Re: Notice of Intent (NOI)
All States Material Group
901 River Road
Deerfield, MA 01373
Map 21 Lot 1 and Map 7 Lot 14
Wetland Consultant Peer Review-Supplemental Review

Per request of the Deerfield Conservation Commission, Stockman Associates LLC has performed a wetland consultant peer review of the revised Notice of Intent (NOI) materials submitted by Kleinfelder on behalf of their client, All States Materials Group, for the improvement of an existing gravel haul road including widening the road, replacing an existing stream crossing, and constructing a pad site to be utilized for a parking area. The project is located at 901 River Road in Deerfield, MA (Map 21 Lot 1 and Map 7 Lot 14). As requested by the Deerfield Conservation Commission, the third-party review excludes the review of the updated Stormwater Report prepared by Kleinfelder. It is our understanding that the Deerfield Conservation Commission is seeking a separate peer review by a licensed professional engineer to evaluate the Stormwater Report and other engineering components.

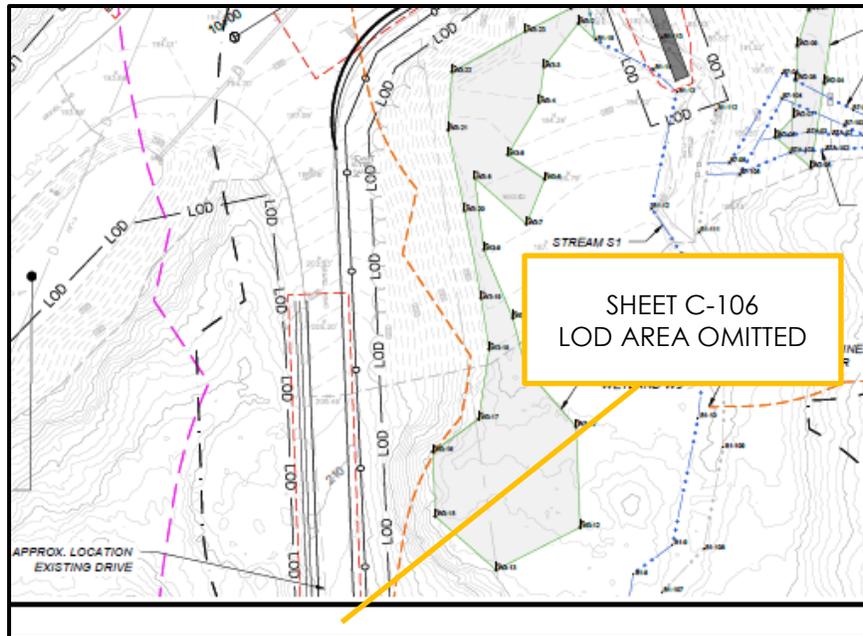
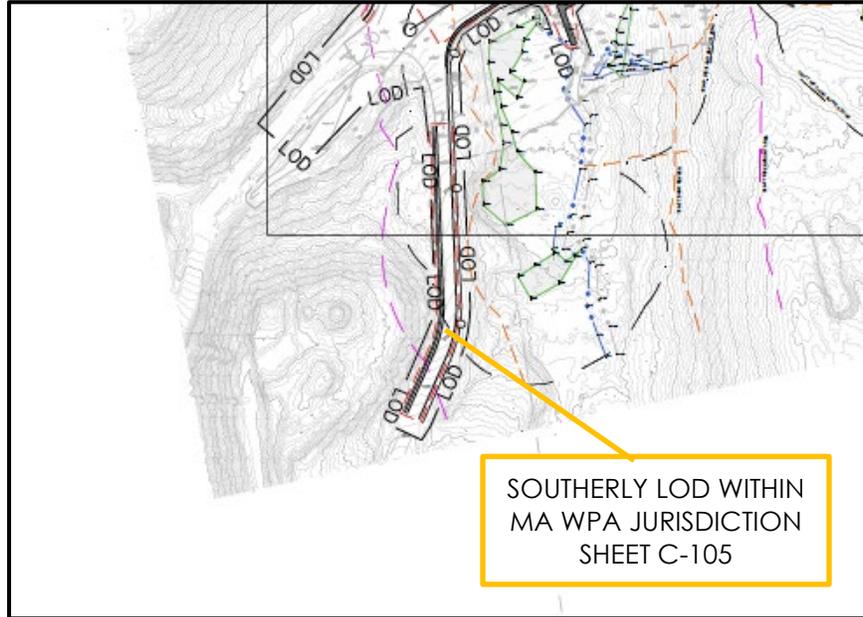
- 7) Per the requirements of 310 10.53(8), the applicant should provide information on the potential for erosion and head cutting.
- 8) The narrative states that the proposed 60-inch replacement culvert will be embedded. A cross-section detailing the embedment of the culvert and substrate should be provided. The depth of the embedded culvert has not been stated in the revised NOI narrative.

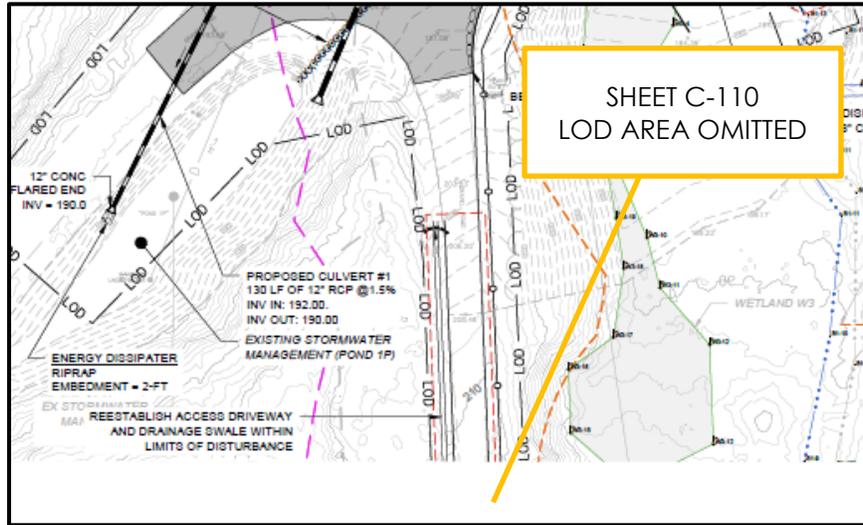
- 9) As previously stated, BVW W3 currently borders on Stream S1. The applicant should address how the connect between BVW W3 and Stream S1 will be maintained with the proposed stream realignment/replacement.

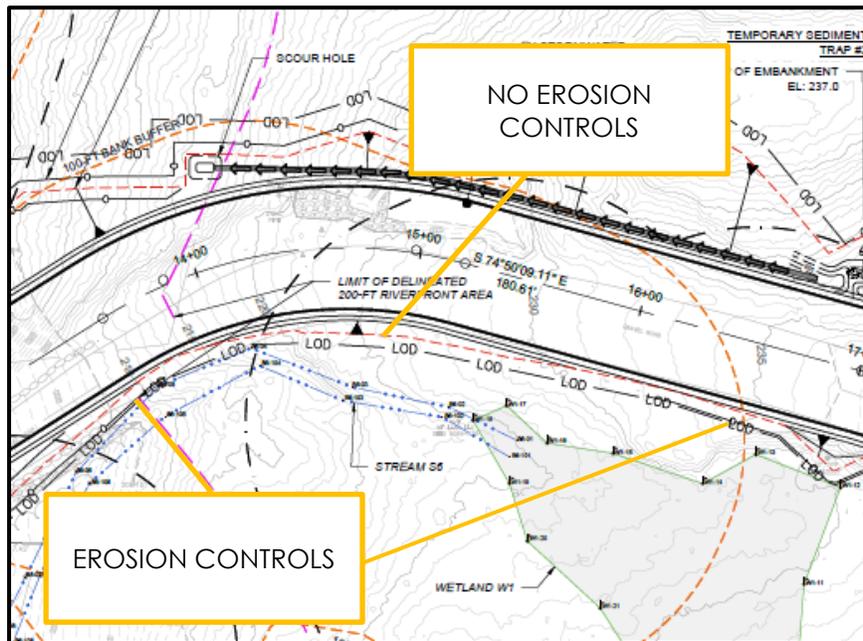
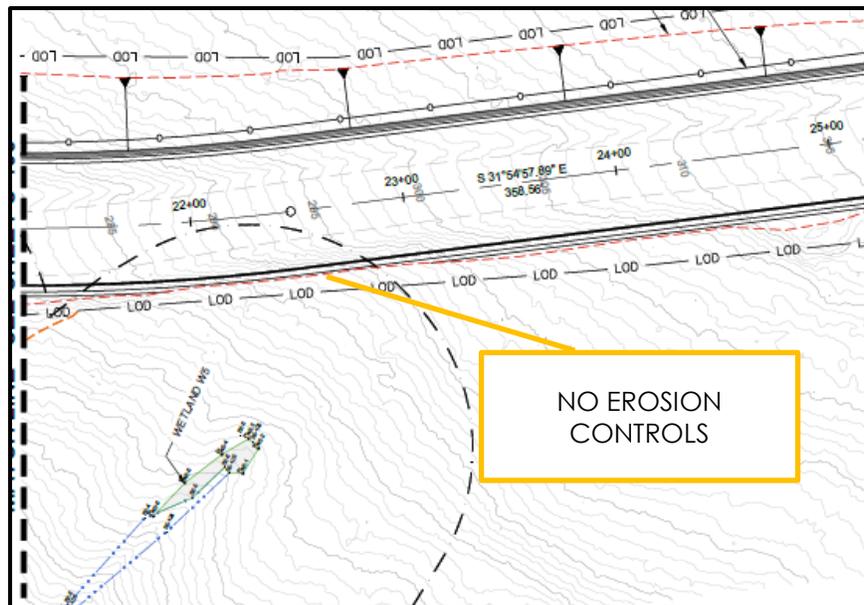
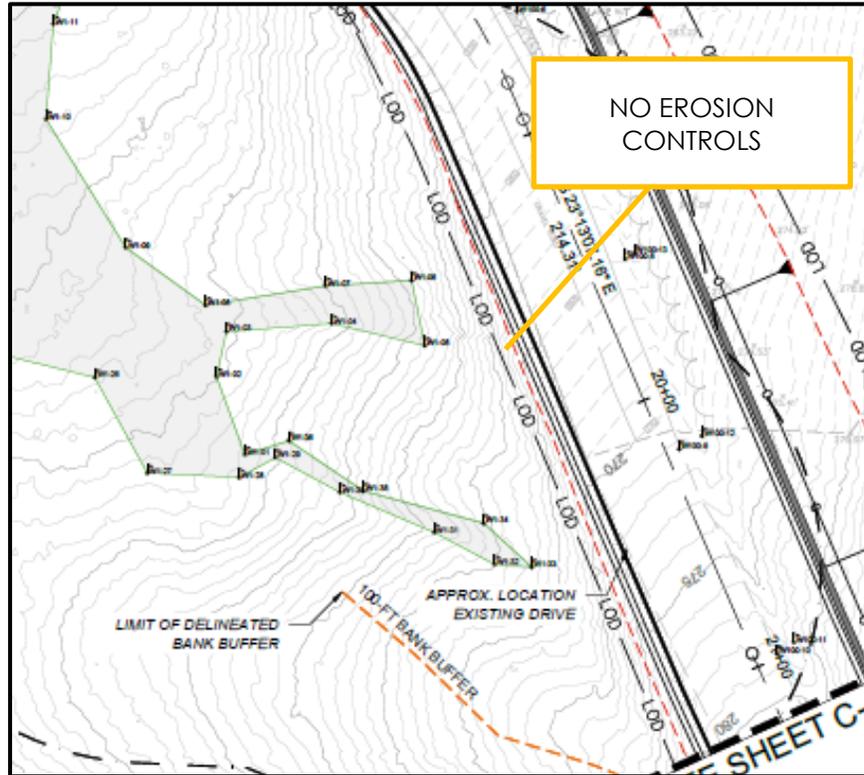
- 1) The Commission should consider further conditioning the stream bypass and culvert installation based on the information provided by Kleinfelder on page 10 of the response letter.
 - a. No work with forecasted rain with 48 hours.
 - b. No work during high flows. Flow must be 34 CFS or less based on the bypass piping calculations provided by the applicant.
 - c. Onsite compliance monitor.
- 2) There is a LOD line shown on sheets C-105 and C-110 extending south along an existing drive. A site plan detailing the LOD and proximal upstream reach of Stream S1 has not been submitted. Sheets C-106 and C-111 omit the area to the south. This area was not reviewed in the field.
